Subject: Submittal of the Response to the Notice of Disapproval for the Investigation Work Plan for Upper Sandia Canyon Aggregate Area and Revision 1

Cross-Reference of NMED NOD Comments and Revisions to Upper Sandia Investigation Work Plan

Figure 4.1-17 Map D proposed sampling locations

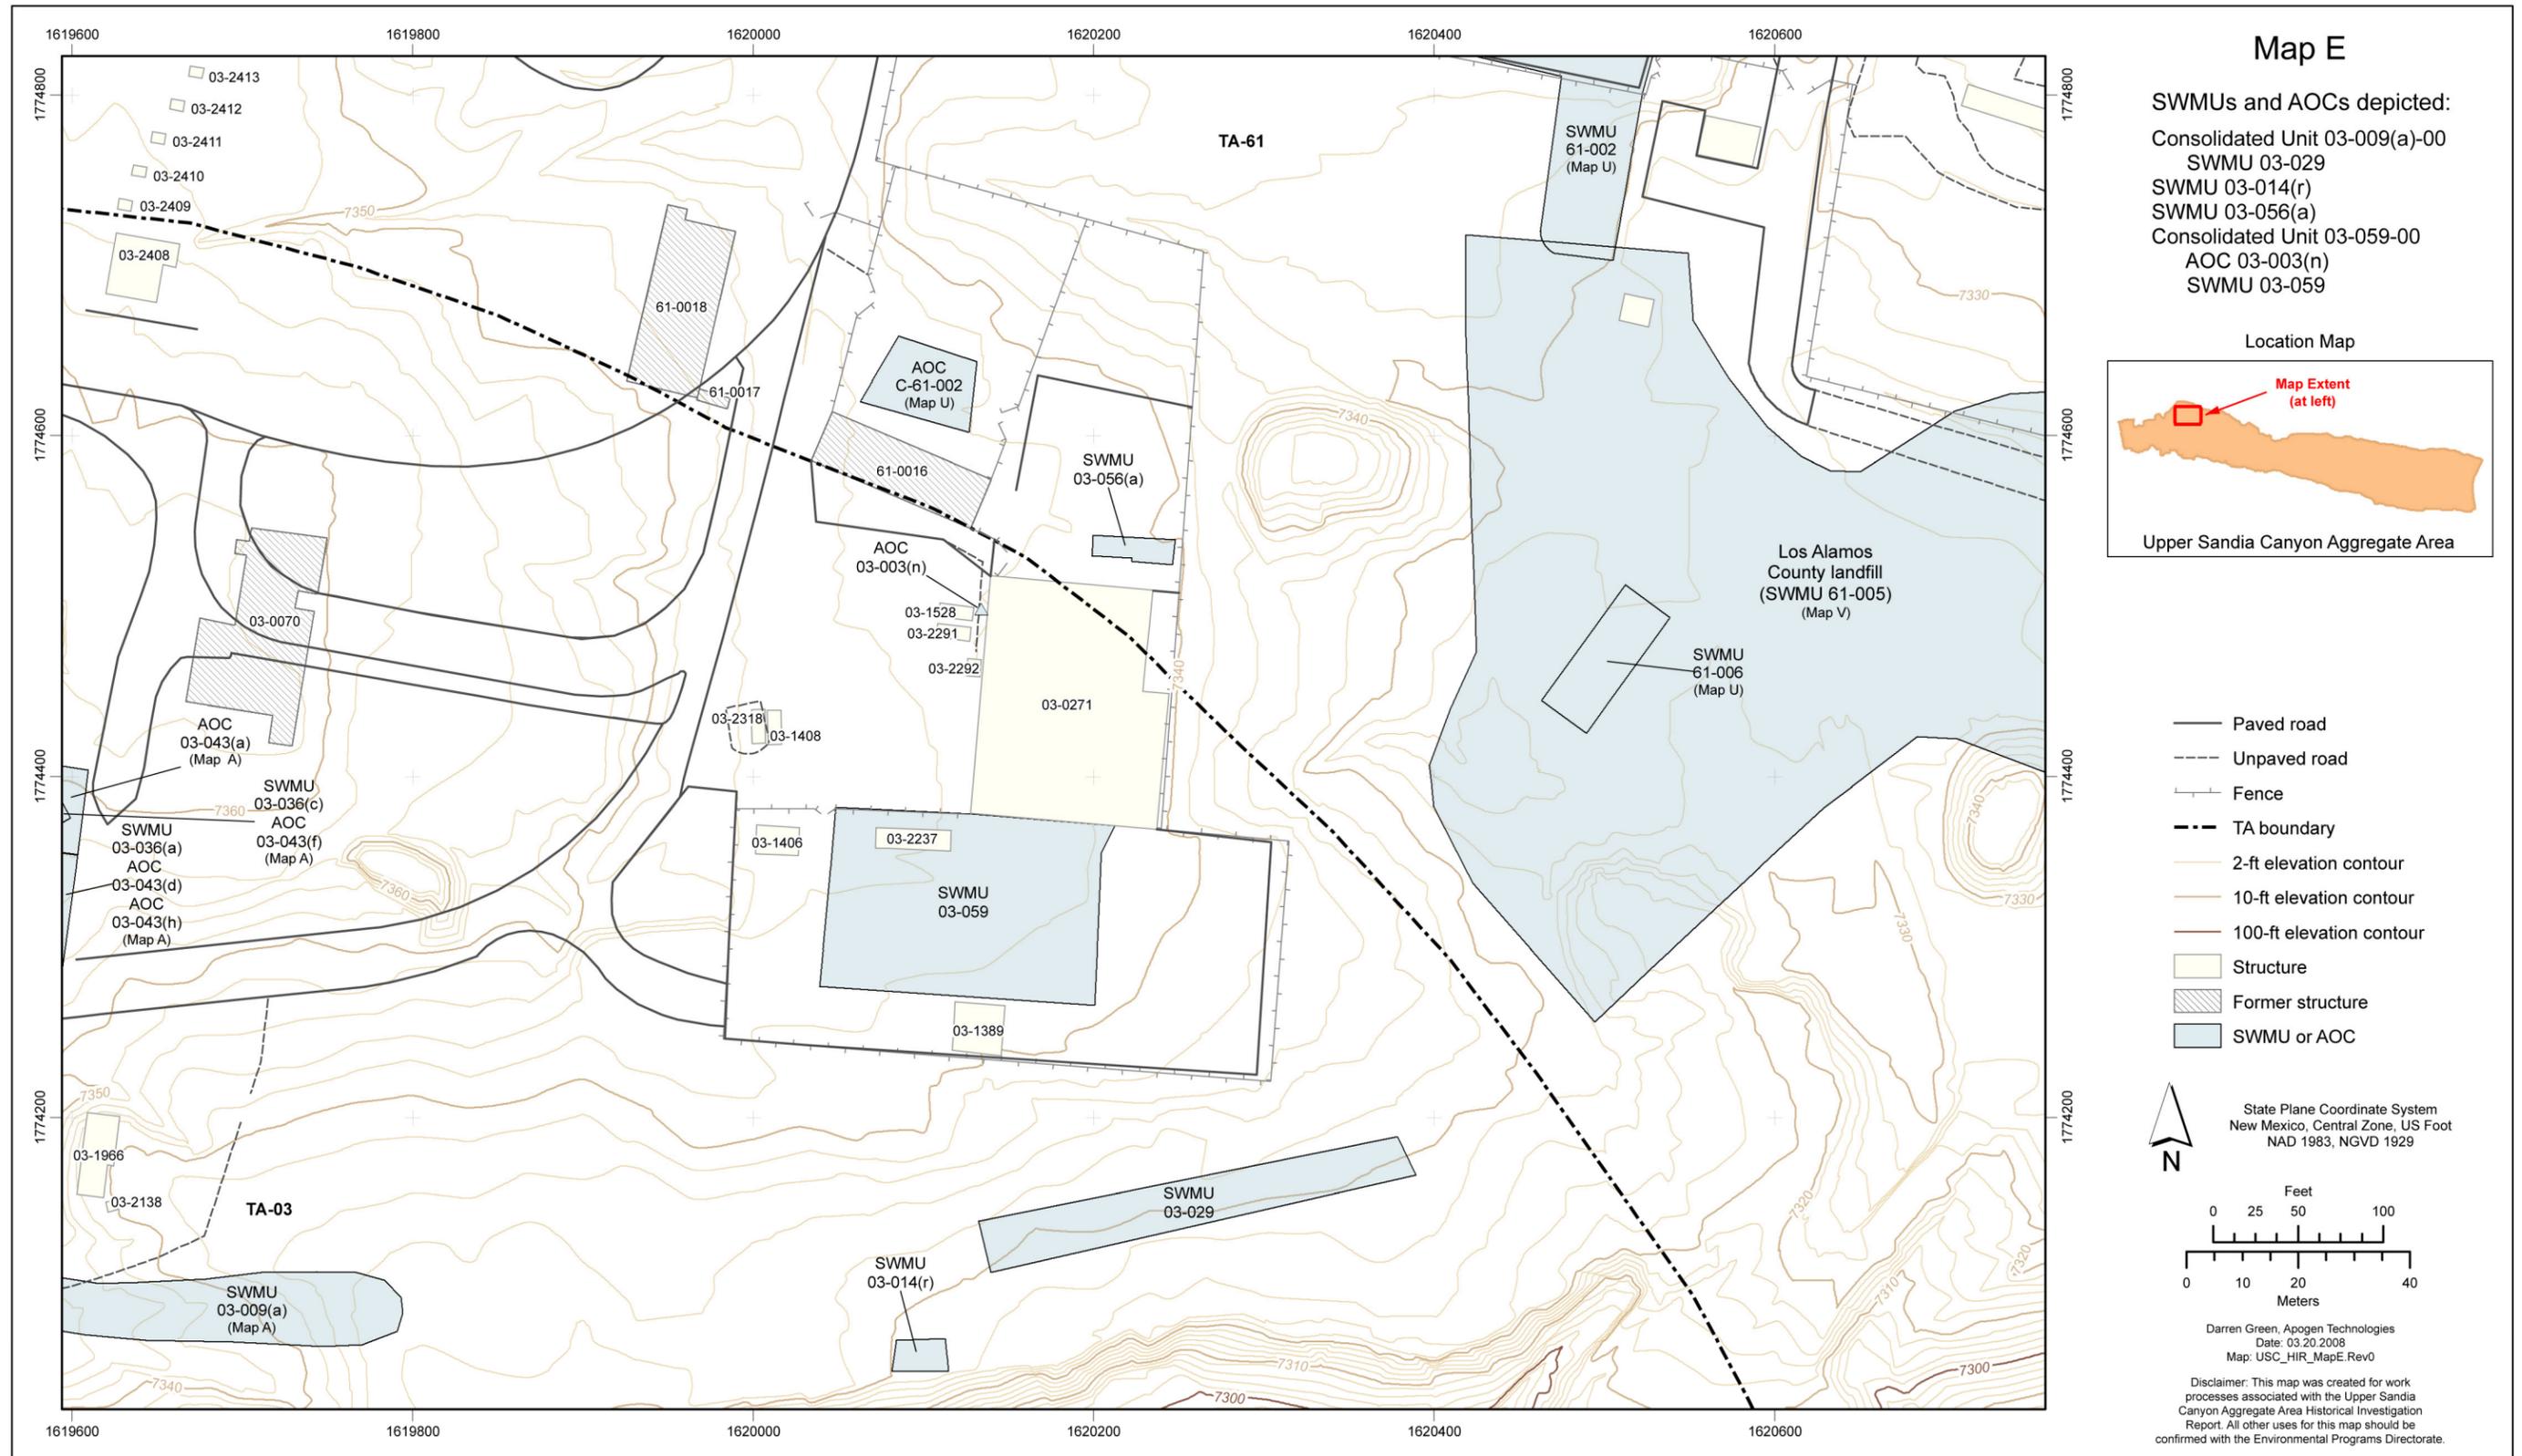
The Permittees must sample the drainage(s) associated with the site from the top of the slope to the toe of the colluvium (see General Comment # 3). The drainages are not clearly depicted on the Figure 4.1-17. The Permittees must revise the figure to depict the drainages.

25. Figure 4.1-13 has not been revised. However, Figure 4.1-17, which presents the proposed sampling locations, has been revised to show the orientation of the outfall pipe and the location of the drainpipe that carried effluent from the outfall pipe. Figure 4.1-17 also shows location 45h-8 at the outfall pipe, where sampling will be conducted under the revised Upper Mortandad Canyon Aggregate Area investigation work plan (LANL 2008, 100750). Discharge below the outfall will be sampled as part of AOC 03-052(b).

27. Figure 4.1-17 has been revised to show the drainage below SWMU 03-052(b) and two additional sampling locations within the stormwater collection area to the northeast across Eniwetok Drive. These samples will be collected at depths of 3 to 4 ft bgs and 5 to 6 ft bgs. Section 4.1.37 and Table 4.0-1 have been revised to include the two new sampling locations.

Figure 4.1-22 Map E proposed sampling locations

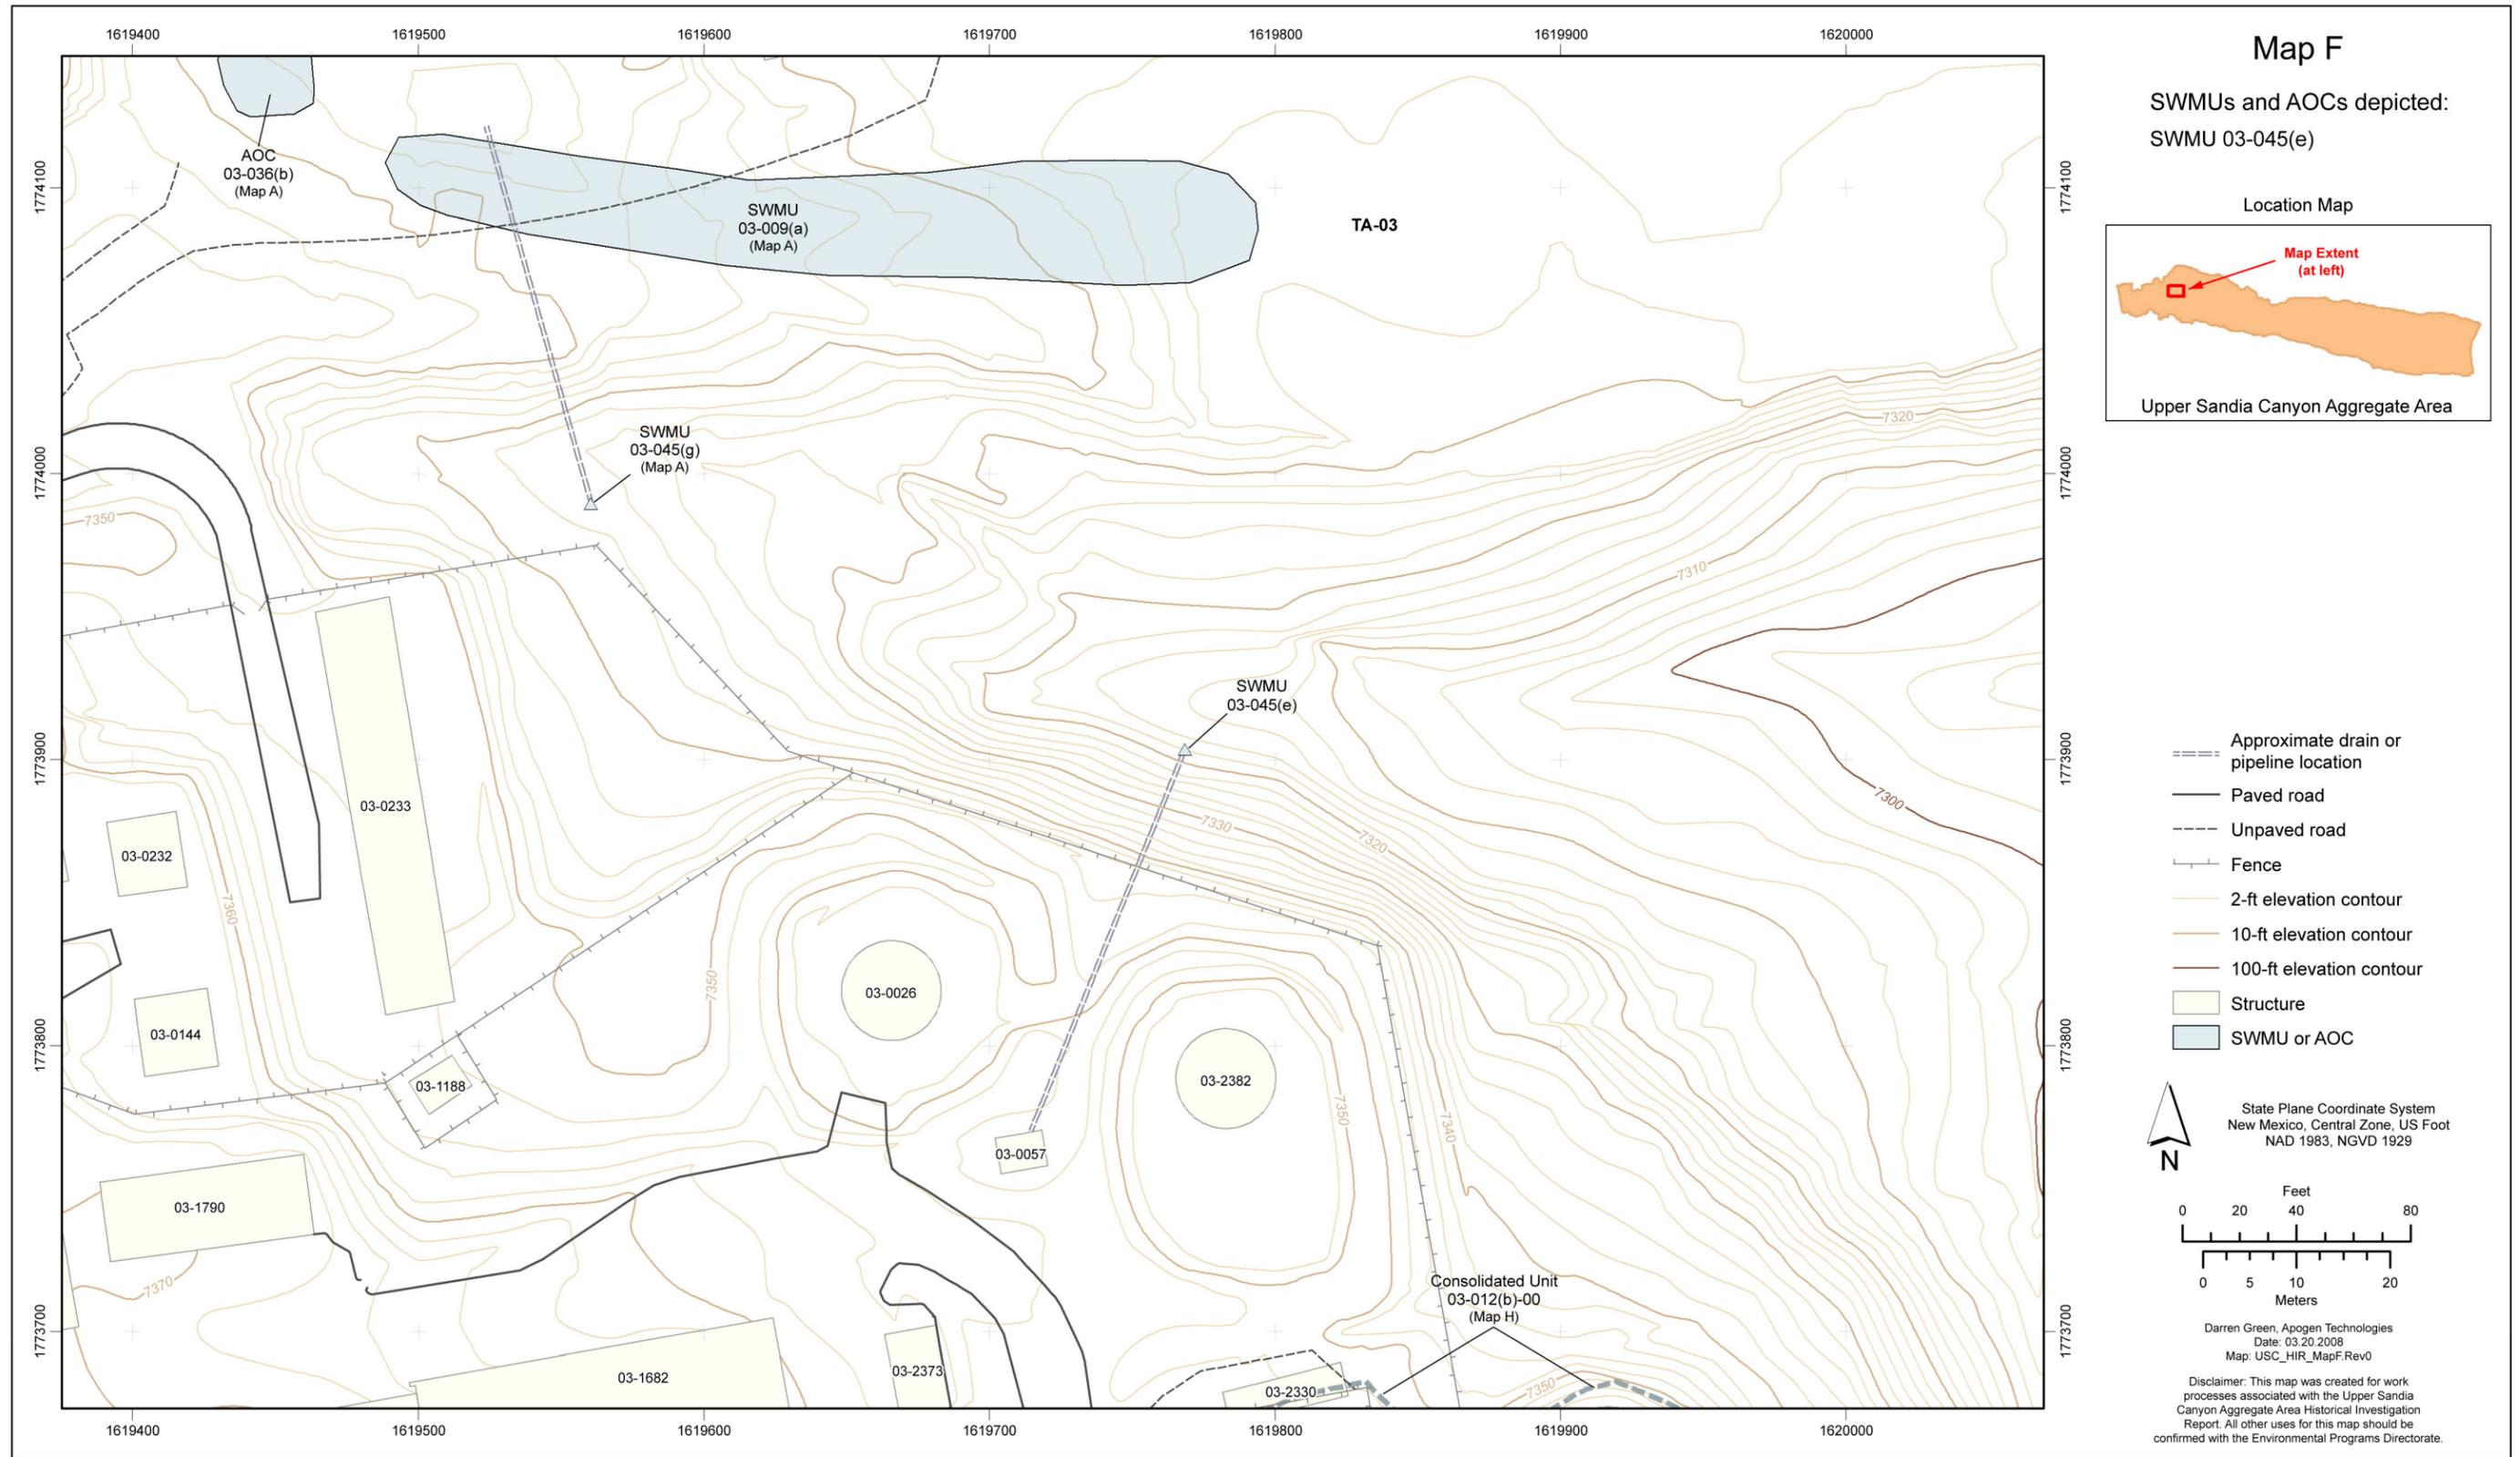
5	For SWMU 03-029, the Permittees must indicate proposed and existing sampling locations in canyons on the relevant figures.	Section 4.1.7.3, Figure 4.1-22, and Table 4.0-1	Section 4.1.7.3, Figure 4.1-22, and Table 4.0-1	The text, figure, and table have been revised to include two additional sampling locations. The text has also been revised to reference the canyon reach sediment sampling locations and to clarify that these data will be assessed in the Upper Sandia Canyon Aggregate Area investigation report. The corresponding figure and table have been revised to show relevant canyon reach and canyon sediment sampling locations.
6	Section 4.1.7.4 and Table 4.1-1 are inconsistent.	Section 4.1.7.4 and Table 4.1-1	Section 4.1.7.4 and Table 4.1-1	The table is correct. The text has been revised accordingly.
7	Section 4.1.7.7, Figure 4.1-2, and Table 4.1-1 are inconsistent.	Section 4.1.7.7, Figures 4.1-1 through 4.1-5, and Table 4.1-1	Section 4.1.7.7, Figures 4.1-1 through 4.1-5, and Table 4.1-1	The text, figures, and table have been revised to be consistent.

- Figure 4.1-22 has been revised to show two additional sampling locations between the canyon edge and the canyon bottom downgradient of SWMU 03-029. The text in section 4.1.7.3 has been revised to reference the additional proposed sampling locations and to clarify that the canyon sediment sampling locations and resulting data will be assessed in the Upper Sandia Canyon Aggregate Area investigation report to confirm that nature and extent of contamination have been determined for this site.
